## Application for Appeal (DS-210)

Case Number: APL-2024-00003 Date Submitted: 4/8/24 Received by: MC

Project Name/Name of Center: (if applicable) Murrieta Hot Springs at Jefferson Apartments

Appellant Statement and Supporting Evidence

**1. LOS (north and south of Murrieta Hot Springs Road)**

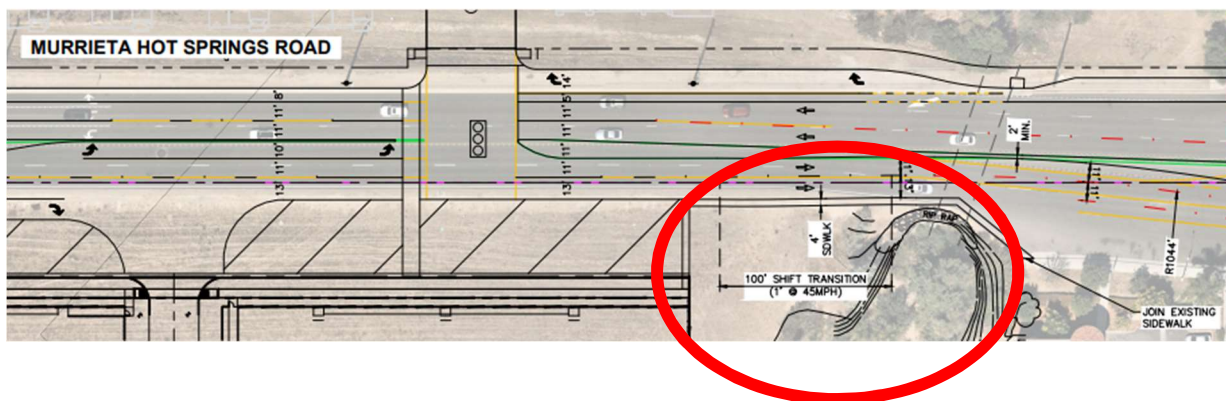
Page 6 of the project's traffic impact analysis (TIA) identifies the City's acceptable traffic level of service (LOS) for the roadway segment on Murrieta Hot Springs Road (MHSR) as LOS C. The IS/MND failed to properly disclose that the Project would conflict with the Level of Service C segment for Murrieta Hot Springs Road by indicating the Project would have no impact on the City's circulation plan, even though the LOS would be worse than the acceptable Level of Service (LOS D). Even though LOS, in and of itself, does not have an environmental impact, the resulting LOS D on the MHSR road segment is an impact on the City's adopted General Plan Circulation Element that the proposed IS/MND should have disclosed for the public's information, as well as why there was no mitigation required pursuant to CEQA. Instead, the IS/MND makes no mention of the inconsistency. The explanation must be included in the TIA and the IS/MND.

The staff report identifies the widening of Murrieta Hot Springs Road (MHSR) over the Yoder Wash as a capital improvement to address the Project's impact on the City's circulation plan. The IS/MND failed to analyze the timing of the widening of Murrieta Hot Springs Road over the Yoder Wash as a possible improvement that would be carried out to ensure the Project's consistency with the City's circulation plan. Since the timing of MHSR widening is unknown, the IS/MND should have identified the delayed timing for the improvement and the impact of the delay in MHSR widening on achieving the City's circulation plan. Until the widening of MHSR takes place, the roadway segment's LOS will exceed the circulation plan's design capacity for MHSR causing reasonably foreseeable significant traffic safety impacts. The IS/MND needs to analyze the delay in the implementation of the widening. The Project will therefore will be in conflict with the City's General Plan Circulation Element until the roadway over Yoder Wash is widened which could be several years from now. Yet there is no analysis of this issue in the IS/MND.

SHEET C6.1	CITY OF MURRIETA ENGINEERING DEPARTMENT	SHEETS
---------------	--	--------

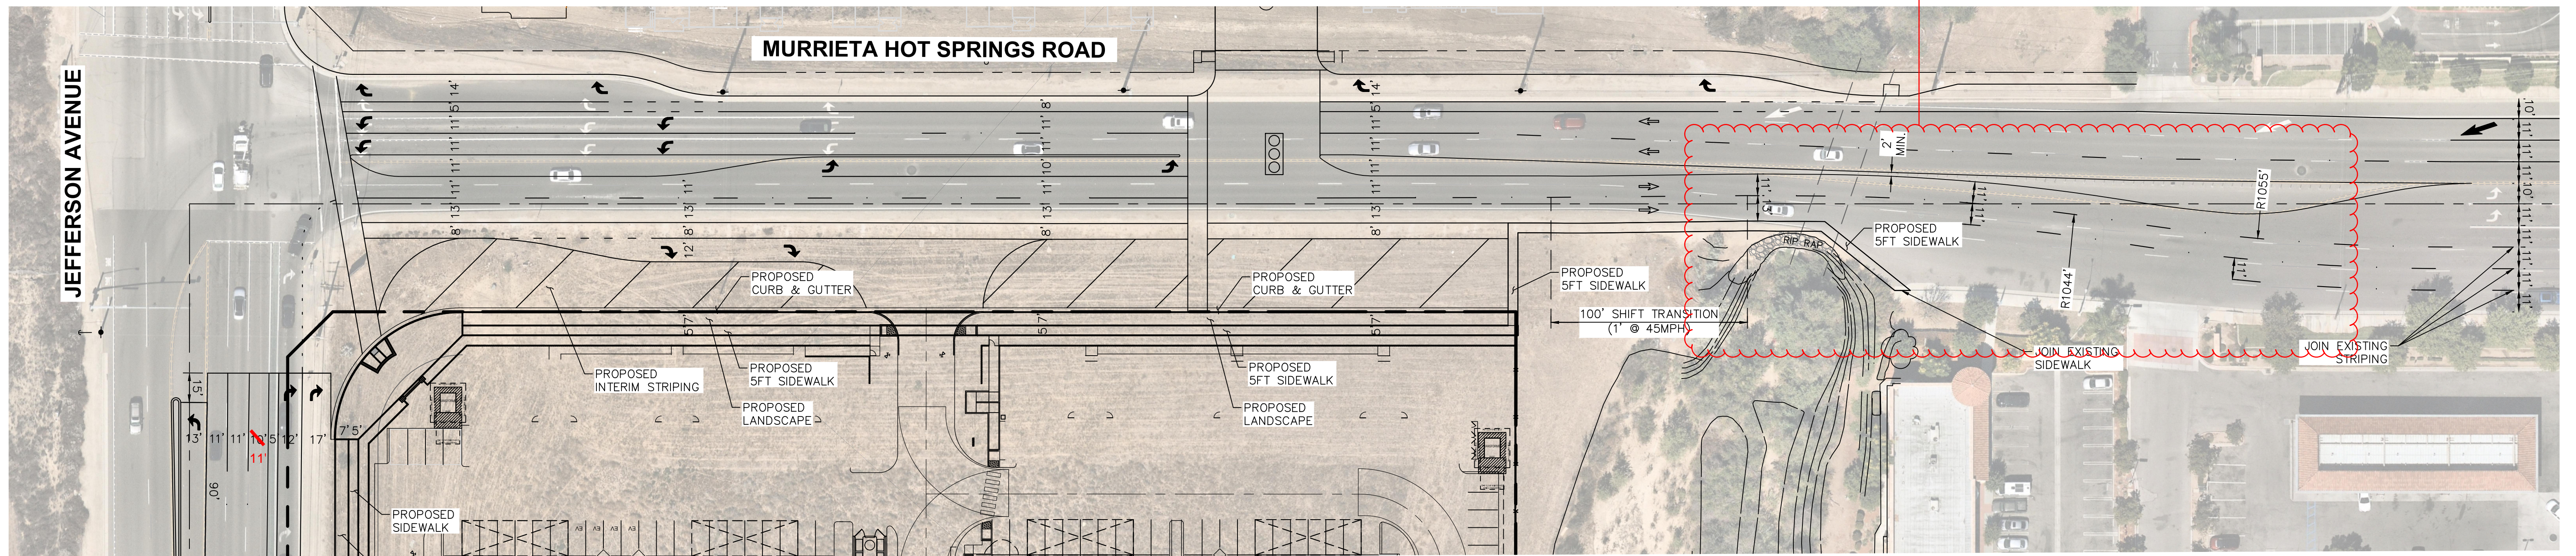
Street design shall meet requirements of City Standard Drawing No. 116, and Caltrans Highway Design Manual, which will be verified when Street Improvement Plans for the public improvements are submitted for review.

Left-turns out of driveway will be restricted. Extend existing median across driveway to prevent left-turns out of the driveway, and maintain the required lane widths for the roadway (10 feet for left-turn lanes, and 11 feet for through lanes per City Standard Drawing No. 101).
